Applicant's Supplemental Information

RE: Technical Information and Recommended Responses to Comments Suggesting Moving Turbines to Address Visual Impacts

RE: Technical Information and Responses to PUC Comments

RE: Technical Information and Recommended Responses to CADFG Comments

Figure 2. Hatchet Ridge Project current proposed layout with no impact on Burney.

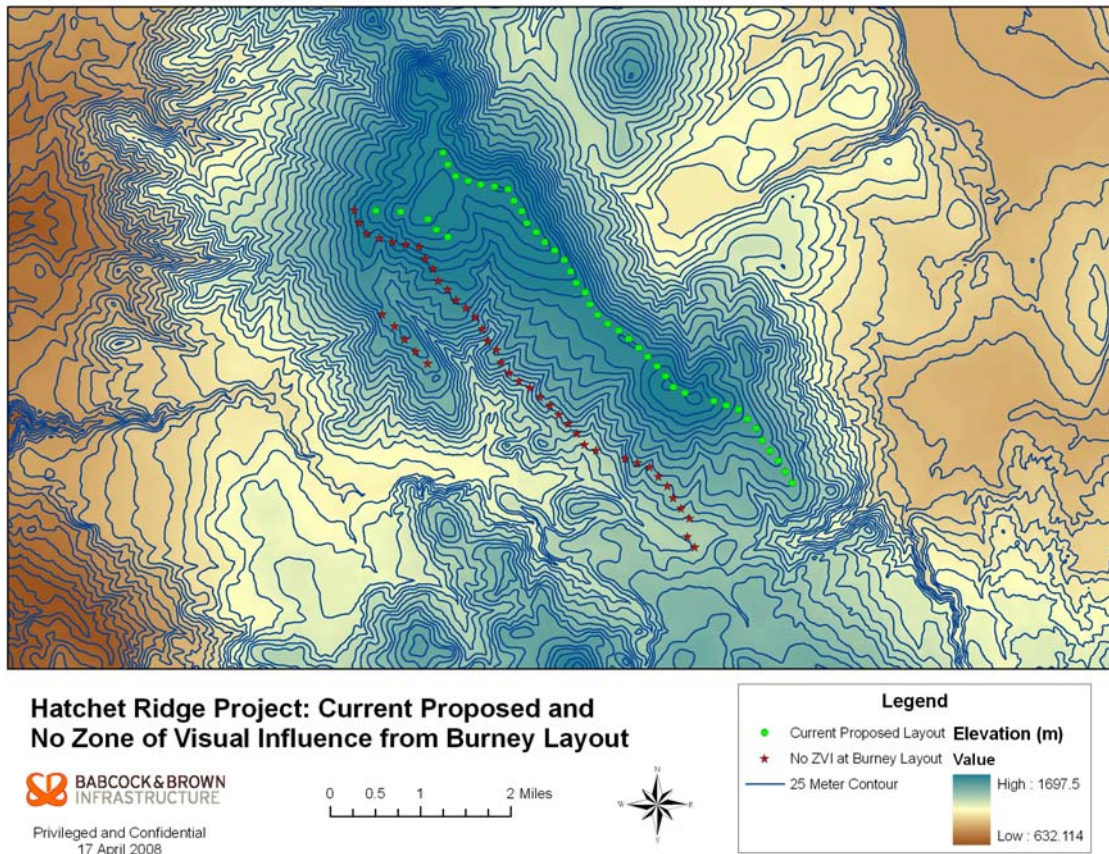
Per the request of Shasta County for the Project Applicant of the Hatchet Ridge Wind Project to come up with a site plan that would eliminate views of the Project from the town of Burney, Babcock and Brown, LP meteorological and technical team (B&B) has; 1) investigated the zone of visual influence (ZVI) for the town of Burney, CA using the proposed Hatchet Ridge Project turbine layout and 2) calculated the production that would occur from relocating the turbines. Based upon the proposed site plan of forty three 2.4 MW MHI turbines mounted on 80 meter towers, as shown on Figure 1, many of the turbines are visible on the ridgeline when viewed from the Burney area looking west.

To remove the turbines from the Burney area zone of visual influence, B&B performed a ZVI turbine location analysis that would eliminate all views of turbines from Burney. To achieve this goal, all turbines would have to be moved southwest approximately one mile and off the main ridgeline. Figure 2 shows a map of the current proposed layout (green dots), and the new layout with the turbines off the ridgeline and longer visible from Burney (red stars).

There are at least three issues associated with moving the turbines to this new location. They include; 1) the wind resource and resulting energy production at the new location, 2) constructability of the new area and, 3) environmental and/or property setback issues. This report is not qualified to comment on environmental or property

In conclusion, moving the turbines sufficiently off the ridgelines as to make them invisible in Burney renders the Project economically and technically unfeasible. Please do not hesitate to call me if you have any questions and/or comments.

Figure 3. View looking West from Burney (No ZVI Layout)

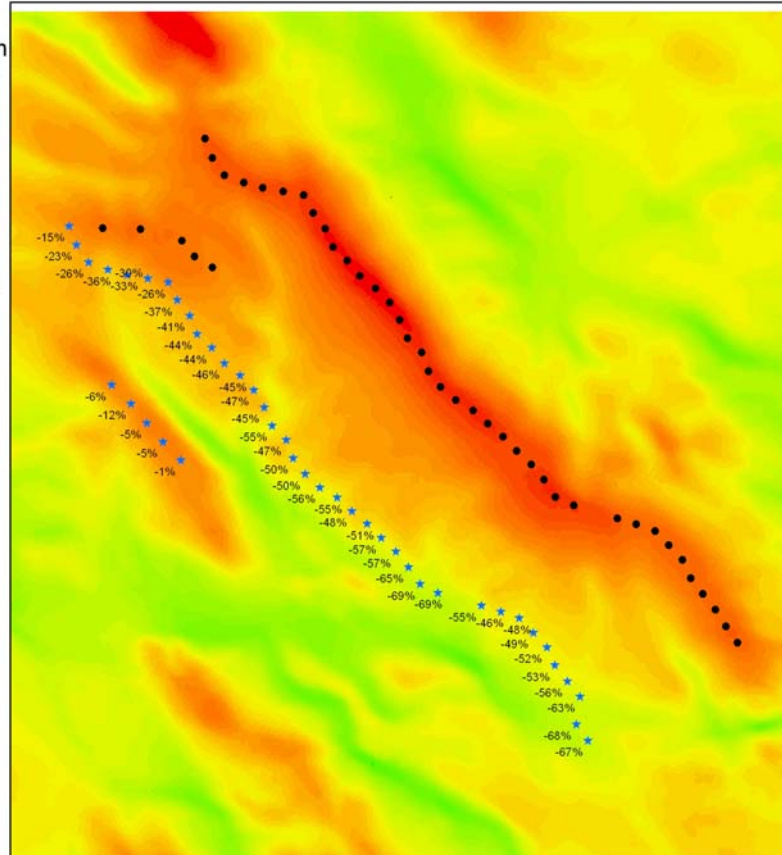
Figure 3 shows the same viewpoint as from figure 1 with the new layout (red stars).

setback issues that might arise from the new site plan. However, B&B's in-house technical department is well versed in employing standard, well understood and accepted wind industry modeling software. Specifically, with multiple years of on-site wind data at Hatchet Ridge and using the Wind Atlas Analysis and Application Program (WAsP) and WindFarmer software packages, we are able to produce wind speed distributions for each turbine location at 25 m grid spacing across a project area. This data is then used to generate net annual energy production estimates for the entire project using the wind turbine's respective power curve and then making appropriate deductions for availability, electrical, icing, wake and other operational losses.
